**PCN# 20200520000.2**  
**Packing material change for Select Device(s)**  
**Change Notification / Sample Request**

**Date:** June 08, 2020  
**To:** MOUSER PCN

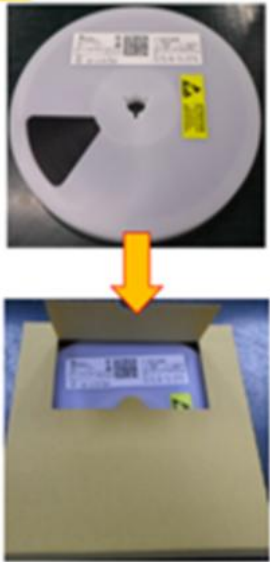
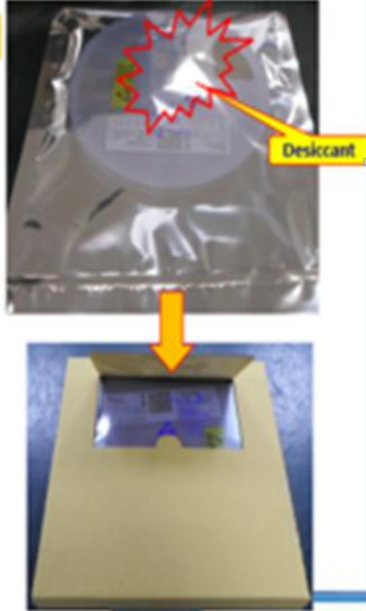
<input type="checkbox"/>	Wafer Fab Process
<b>PCN Details</b>					
<b>Description of Change:</b>					
This change notification is to announce the addition of using ESD sealed bag for the shipping reel before placing inside the Pizza Box for select devices listed in the "Product Affected" Section.					
	<b>From</b>		<b>To</b>		
Packing Description	Reel into Pizza Box		Reel in ESD Sealed Bag inside the Pizza Box		
Visual comparison					
<b>Reason for Change:</b>					
Prevent lead discoloration / oxidation leading to solderability Test failure					
<b>Anticipated impact on Form, Fit, Function, Quality or Reliability (positive / negative):</b>					
None					
<b>Anticipated impact on Material Declaration</b>					
<input checked="" type="checkbox"/>	No Impact to the Material Declaration	<input type="checkbox"/>	Material Declarations or Product Content reports are driven from production data and will be available following the production release. Upon production release the revised reports can be obtained at the site link below <a href="http://www.ti.com/quality/docs/materialcontentsearch.tsp">http://www.ti.com/quality/docs/materialcontentsearch.tsp</a>
